Product hierarchy no. *				Part no.	SBU	Type / Description	Customer part no.
SBU	PG	PUG	Type				
02	005	016	0000001101	See list below	Power entry modules without line filter	8843-2 SP

2 Type of change

Product Change Notification						8843-2 SP Change of inscription	
owner	creation date	release date	released by	change order no	rev	page	D10-042-126
sariogar	09.01.2020	18.03.2020	sariogar	2018961	A	1 of 2

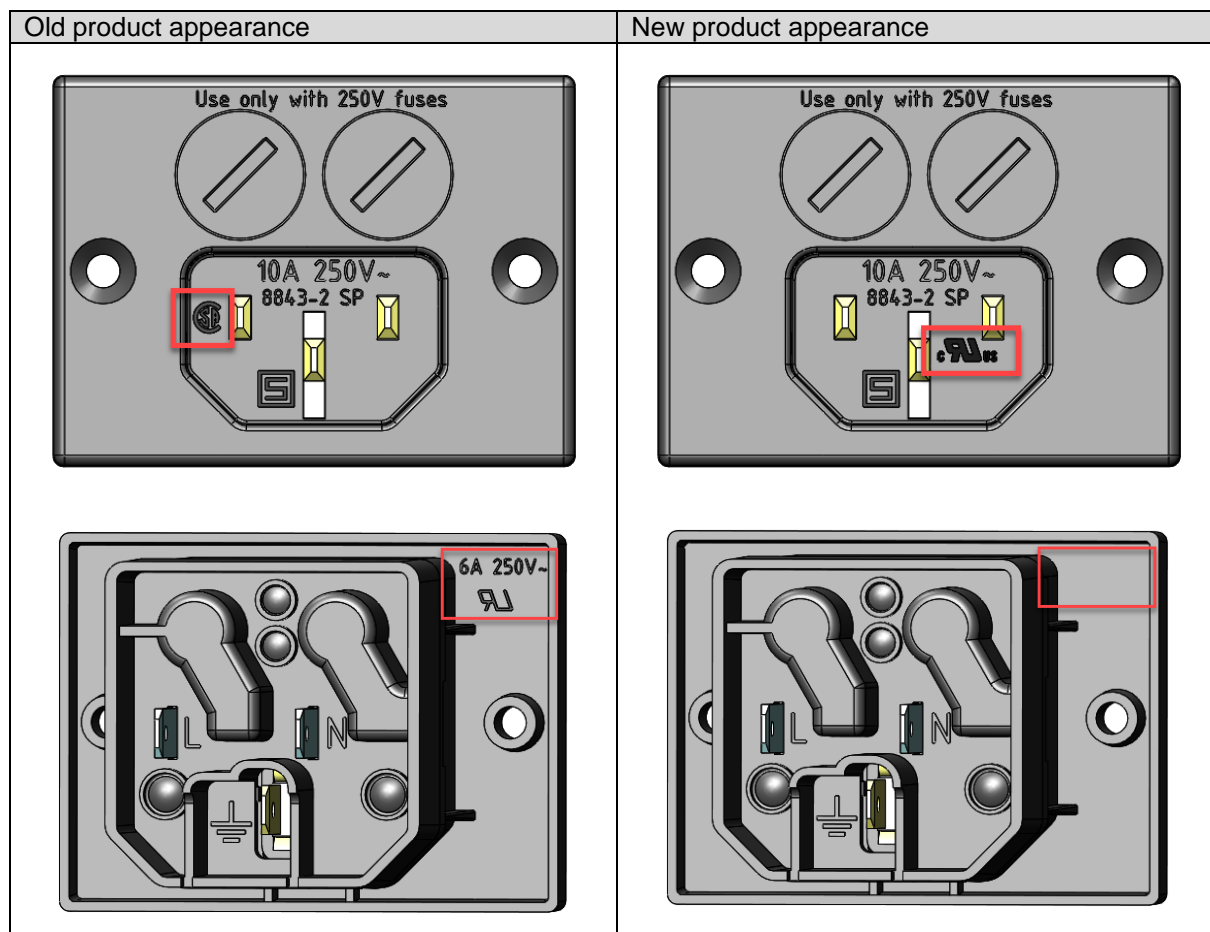
Change of approval and rating markings on the moulding body.

Approvals CSA and UR replaced to cURus. 6A 250V~ removed.

Standards update according to the new UL/CSA 60320-1
